HUMAN FACTORS EVALUATION OF THE SINCGARS ICOM RADIO

Richard L. Palmer

U.S. Army Research Institute
Fort Hood Field Unit

April 1987

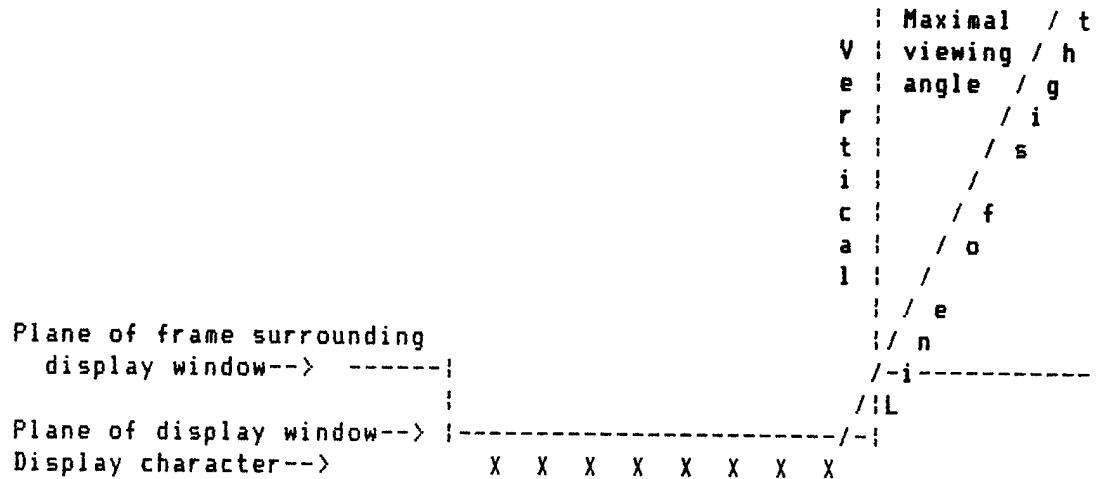
2.01 **OBSERVATION:** The maximal viewing angles for the ICOM display were measured by taking the angle between a vertical line from the plane of the display frame at the edge of the display window and a line of sight in the horizontal plane slanting away from the vertical line to the point where the edges of the characters began to be occluded from view, as in the following illustration for viewing the display from the right side:

- 30 degrees from the top of the display
- 27 " bottom "
- 30 " right "
- 30 " left "

IMPACT: The nominal maximal viewing angles are improved over the non-ICOM radio (for which they were approximately 12 degrees above and below, 20 degrees to the left, and 25 degrees to the right). The improvement is, however, much greater than the nominal values would indicate because of the change from a five-character, seven-segment LED to an eight-character (seven used), 5 x 7 dot matrix LED. The dot matrix allows much greater detail in the display characters, thus making them considerably more distinct from one another even if the entire character is not visible because of extreme viewing angle. Furthermore, the first and eighth characters of the display (which graphically indicate signal strength and low battery condition, respectively) are not used for alphabetical or numerical messages, and the seventh character is not used at all; therefore the effective readability of the display (for alphanumeric prompts and feedback) from extreme side-viewing angles is greater than that indicated by the nominal values given. When the first, seventh, and eighth characters are not considered, the effective angles for viewing from the left and right are approximately 62 and 82

COMMENTS/POSSIBLE IMPROVEMENTS: The fact that the display characters are considerably inset from the surface of the display limits the maximal viewing angles. Design efforts should attempt to minimize this inset. The bottom viewing angle (27 degrees) could possibly be widened by tapering the top edge of the frame around the keypad. (Of course, nighttime security considerations tend to work in opposition to viewing considerations, and in some situations there may be reasons to minimize rather than maximize viewing angles.)

Figure 1. Front panel of the SINGGARS first-generation Integrated COMSEC (ICOM) radio.

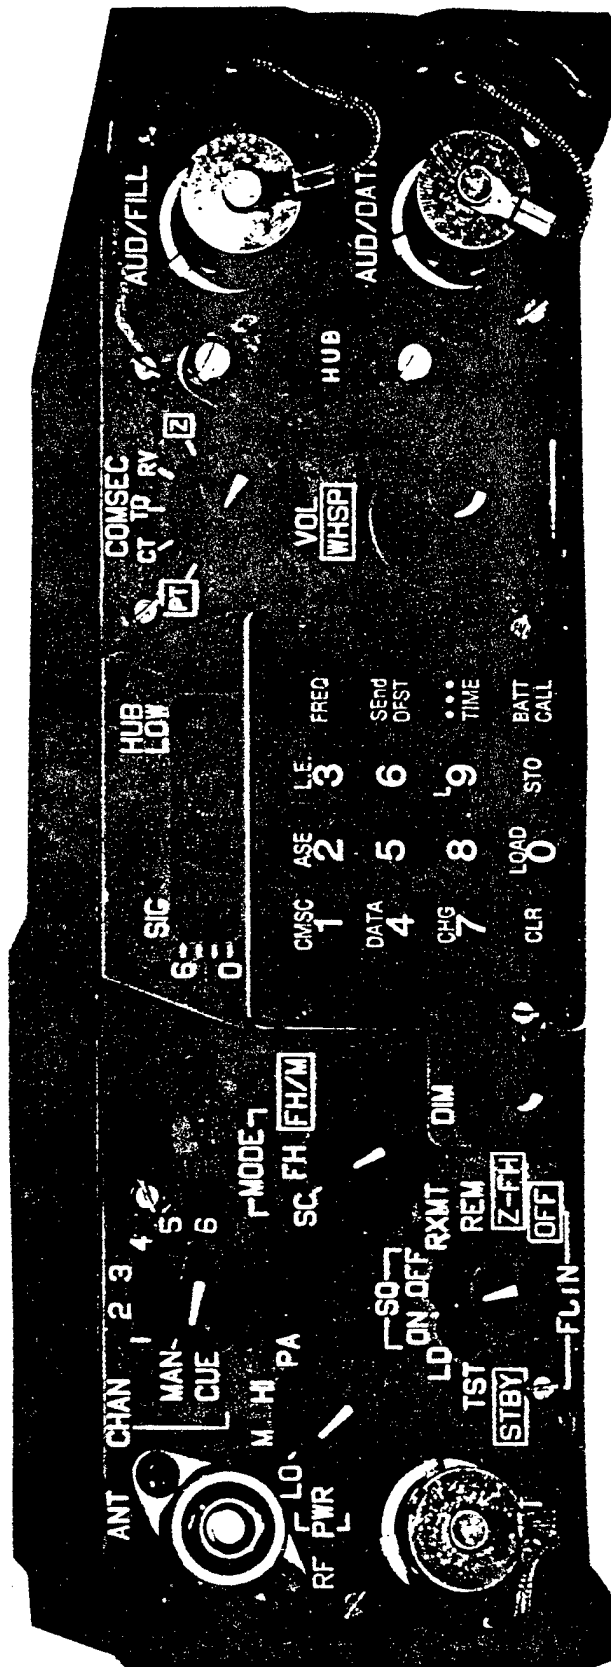
1.01 **OBSERVATION:** The RF PWR switch can be set midway (on the "high points") between normal settings. (Cf. Observation 1.02.)

IMPACT: A specific violation of MIL-STD-1472C (par. 5.4.2.1.1.4.c). Display anomalies result from keying the handset when the control switch is set between normal stops: When the control is set between "M" and "HI," the signal strength display indicator shows a 3 x 7 dot matrix (indicating "HI"); when the control is set between "M" and "LO," the indicator may show either a 3 x 1 ("LO") matrix (bottom line) or a 3 x 3 ("M") matrix (bottom three lines). (Cf. Observation 2.02.)

1.02 **OBSERVATION:** The CHAN switch can be positioned between normal settings at the high points of resistance. (Cf. Observation 1.01.)

IMPACT: A specific violation of MIL-STD-1472C (par. 5.4.2.1.1.4.c). On the radio examined, the display reacted as follows:

1.05 **OBSERVATION:** The visual parallax distortion associated with the rotary controls on the ICOM radio (as on the non-ICOM radio) is considerable, especially for the FCTN switch.

1.06 **OBSERVATION:** The front panel controls (including the keyboard) are not illuminated for use in low-light or no-light situations. Operators of the non-ICOM radio have viewed this as a significant problem.

1.07 **OBSERVATION:** The volume control knob can be accidentally moved because of its lack of sufficient resistance to turning.

3.01 **OBSERVATION:** The label "RF PWR" on the power switch is unnecessarily specific and abbreviated.

3.02 **OBSERVATION:** All controls and connectors except the function switch are labeled at the top. The function switch is labeled at the bottom.

COMMENTS/POSSIBLE IMPROVEMENTS: Improve the design of the switch to eliminate its ability to stop midway between intended settings. (The problem is not considered serious from a human factors perspective)

COMMENTS/POSSIBLE IMPROVEMENTS: Same as for Observation 1.01.

COMMENTS/POSSIBLE IMPROVEMENTS: Control knobs should be designed to minimize visual parallax problems. Some modification of the knobs on the control panel of the ICOM could help (ref. MIL-STD-1472C, par. 5.4.2.1.1.3 & Figure 4), as might a reduction in the number of positions on the FCTN switch (cf. Observation 3.03, Comment).

COMMENTS/POSSIBLE IMPROVEMENTS: Increase the control's resistance to movement.

COMMENTS/POSSIBLE IMPROVEMENTS: Simplify the label by changing it to "POWER."
